ACCESSION NBR: 8412010013 DOC. DATE: 84/11/20 NOTARIZED: NO DOCKET #
 FACIL: 50-410 Nine Mile Point Nuclear Station, Unit 2, Niagara Moho 05000410
 AUTH. NAME AUTHOR AFFILIATION
 MANGAN, C.V. Niagara Mohawk Power Corp.
 RECIP. NAME RECIPIENT AFFILIATION
 SCHWENCER, A. Licensing Branch 2

SUBJECT: Forwards marked-up Tech Specs. Tech Specs, representing util
 policy decision to utilize 24 month (from startup to
 startup) refueling outages.

November 20, 1984
(NMP2L 0253)

Re: Nine Mile Point Unit 2
Docket No. 50-410

Figure 3.1.5-2

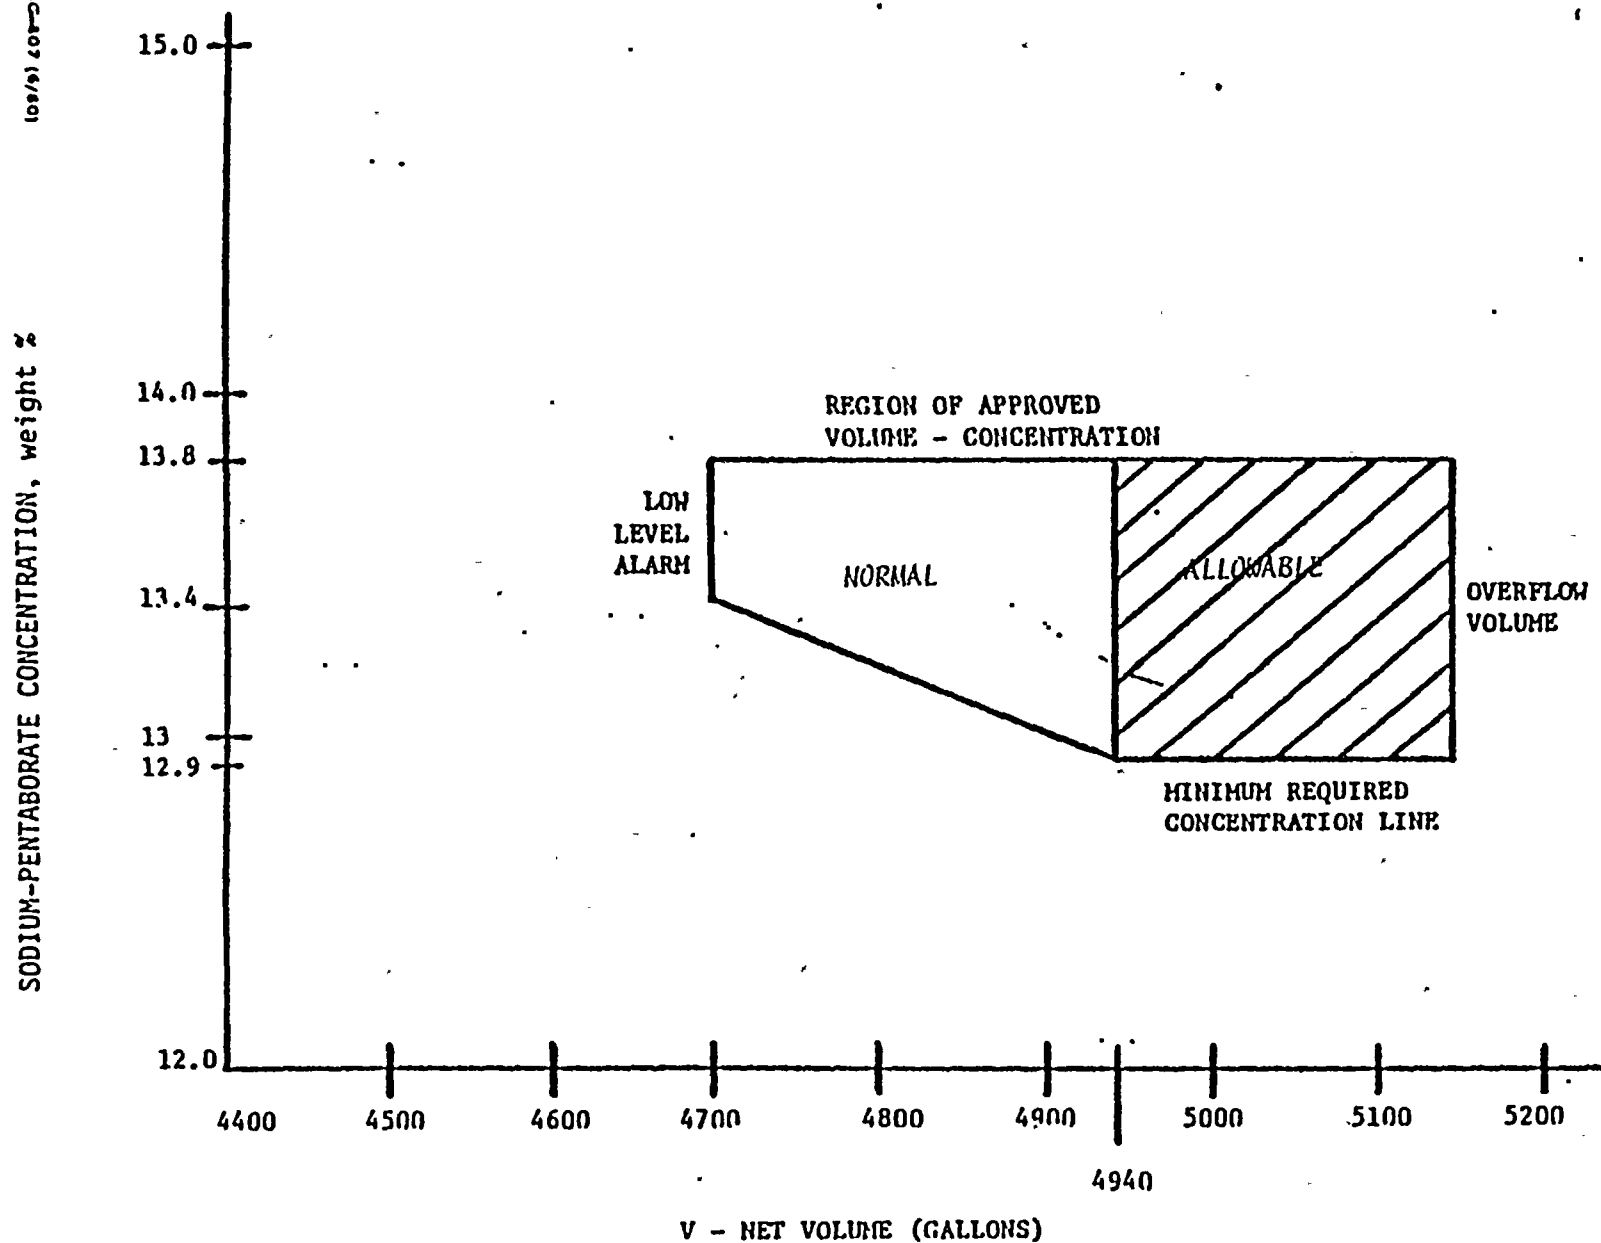
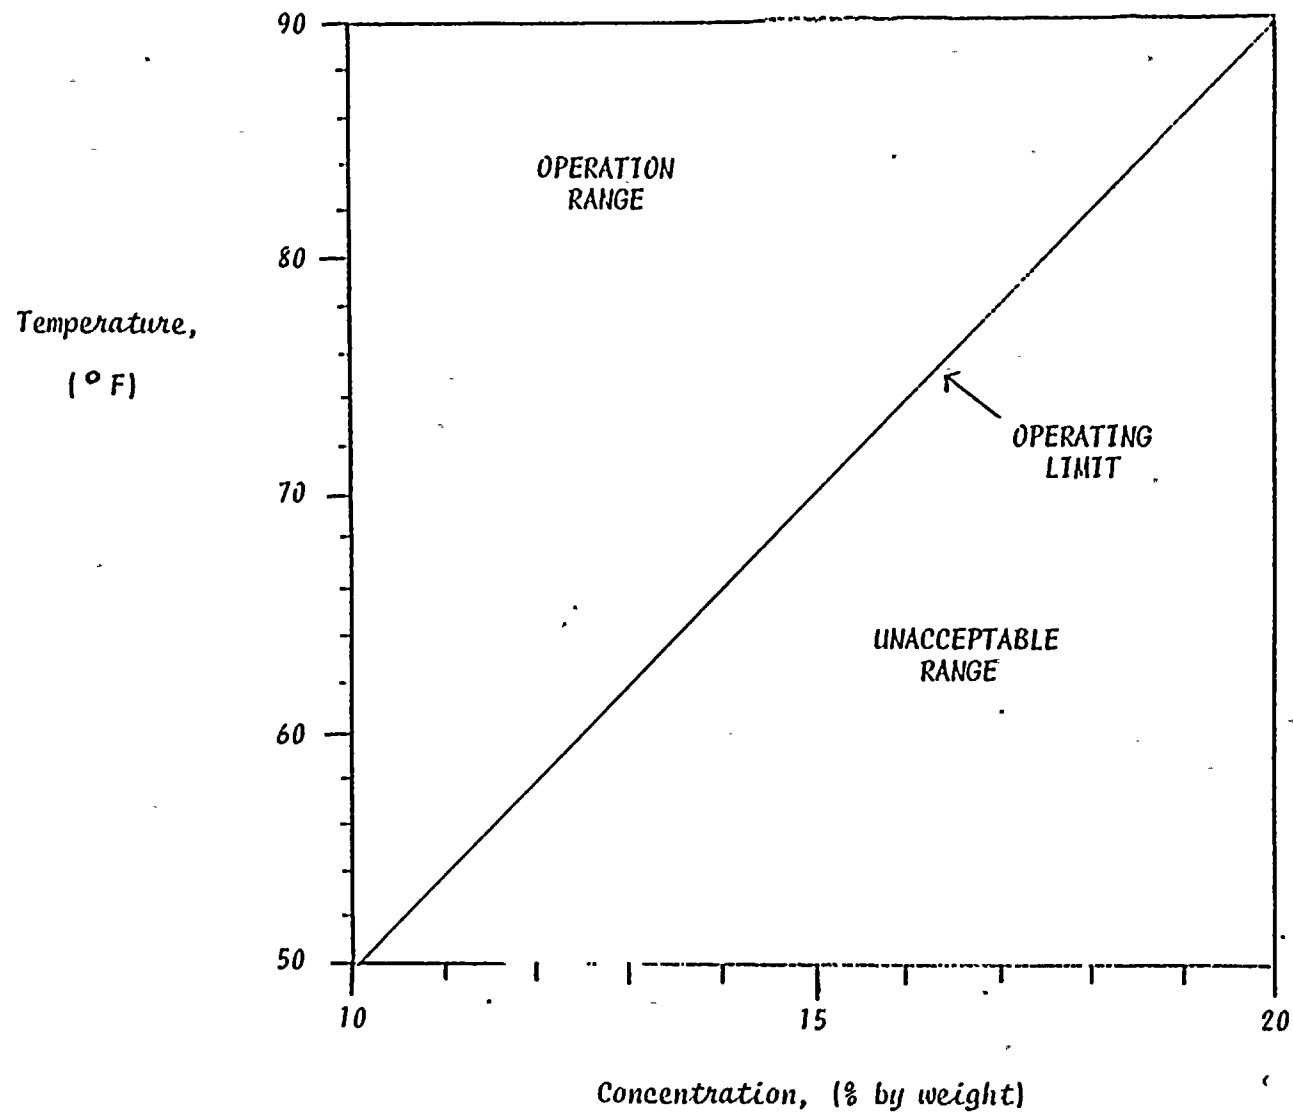
- a. At least once per 24 hours by verifying that;
 1. The temperature of the sodium pentaborate solution ^{in the storage tank} is ~~within the limits of figure 3.1.5-1~~ $\geq 70^{\circ}\text{F}$ on Figure 3.1.5-2.
 2. The available volume of sodium pentaborate solution is ~~greater than or equal to () gallons~~ within the limits of figure 3.1.5-1.
 3. The heat tracing circuit is OPERABLE by determining the temperature of the (pump suction piping) to be greater than or equal to ~~(70)^oF~~ on Figure 3.1.5-2.

1. Verifying the continuity of the explosive charge.
2. Determining that the available ^{net} weight of sodium pentaborate is greater than or equal to ~~(5680)~~ lbs and the concentration of boron in solution is within the limits of Figure 3.1.5-1 by chemical analysis.*
3. Verifying that each valve, manual, power operated or automatic, in the flow path that is not locked, sealed, or otherwise secured in position, is in its correct position.

*This test shall also be performed anytime water or boron is added to the ^{70°F} solution or when the solution temperature drops below the limit of Figure 3.1.5-1.

Figure 3.2.1-1

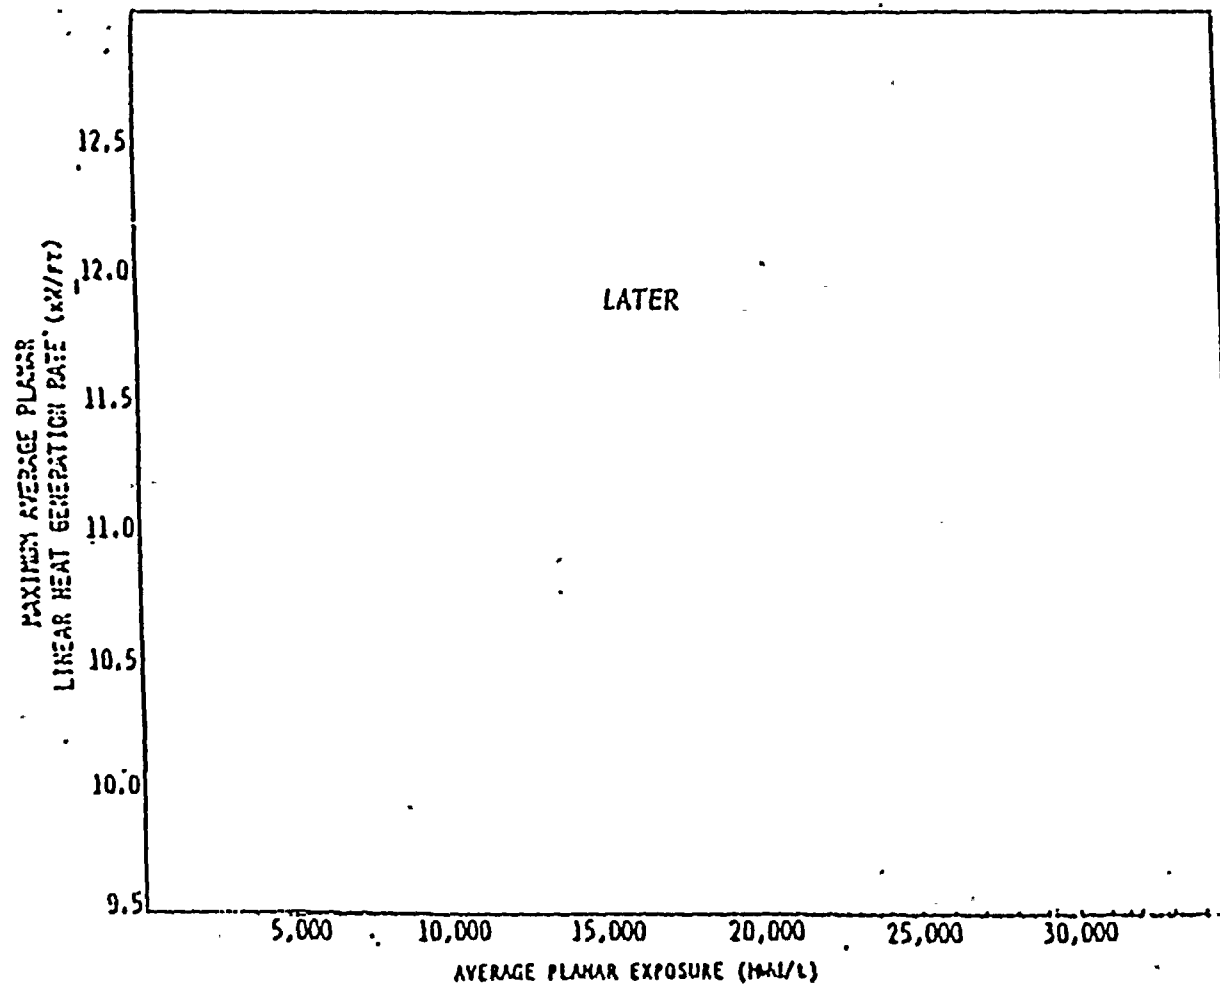
3.2.1 All AVERAGE PLANAR LINEAR HEAT GENERATION RATES (APLHGRs) for each type of fuel as a function of AVERAGE PLANAR EXPOSURE shall not exceed the limits shown in Figure 3.2.1-1, ~~3.2.1-2, and 3.2.1-3.~~

With an APLHGR exceeding the limits of Figure 3.2.1-1, ~~3.2.1-2, or 3.2.1-3,~~ initiate corrective action within 15 minutes and restore APLHGR to within the required limits within 2 hours or reduce THERMAL POWER to less than ~~25~~25% of RATED THERMAL POWER within the next 4 hours.

FIGURE 3.1.3-1 K_f AS A FUNCTION OF PERCENT OF CORE FLOW

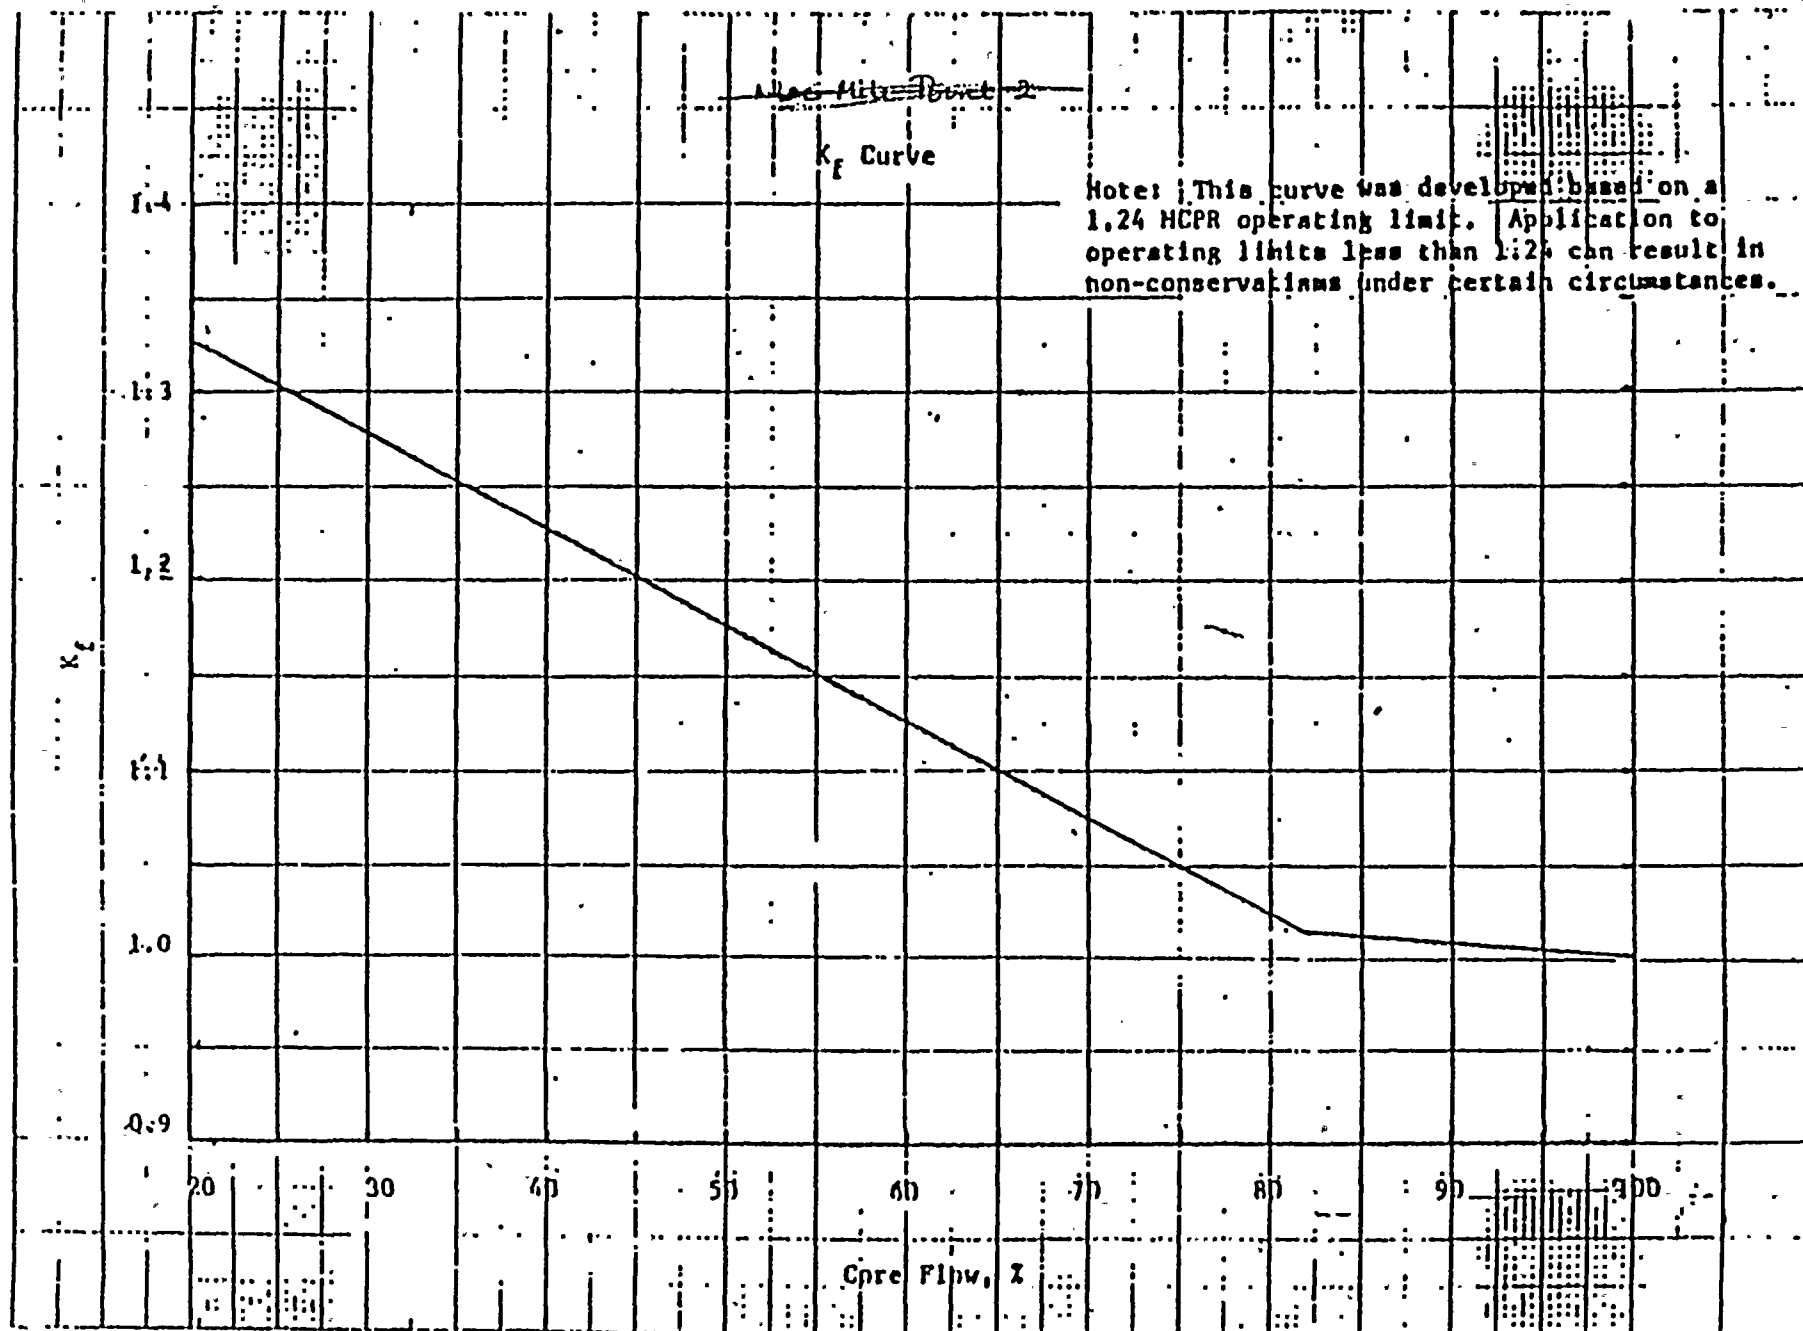
(1.24)
3.2.3 The MINIMUM CRITICAL POWER RATIO (MCPR) shall be equal to or greater than the MCPR limit times the K_f shown in ~~Figure 3.2.3-1~~, (provided ^{7 of fig. 3.2.3-1} that the end of cycle recirculation pump trip (EOC-RPT) system is OPERABLE per Specification 3.3.4.2), with MCPR for 3 x 8 fuel (1.29).

- a. b. With MCPR less than the MCPR limit times K_f shown in Figure 3.2.3-1, initiate corrective action within 15 minutes and restore MCPR to within the required limit within 2 hours or reduce THERMAL POWER to less than (25)% of RATED THERMAL POWER within the next 4 hours.

The purpose of the K_f factor of Figure 3.2.3-~~(1)~~(2) is to define operating limits at other than rated core flow conditions. At less than 100% of rated flow the required MCPR is the product of the MCPR and the K_f factor. The K_f factors assure that the Safety Limit MCPR will not be violated. The K_f factors were derived using THERMAL POWER and core flow corresponding to $\{105\}\%$ of rated steam flow.

~~The K_f factors shown in Figure 3.2.3-1 are conservative for the General Electric plant operation because the operating limit MCPRs of Specification 3.2.3 are greater than the original 1.20 operating limit MCPR used for the generic derivation of K_f .~~
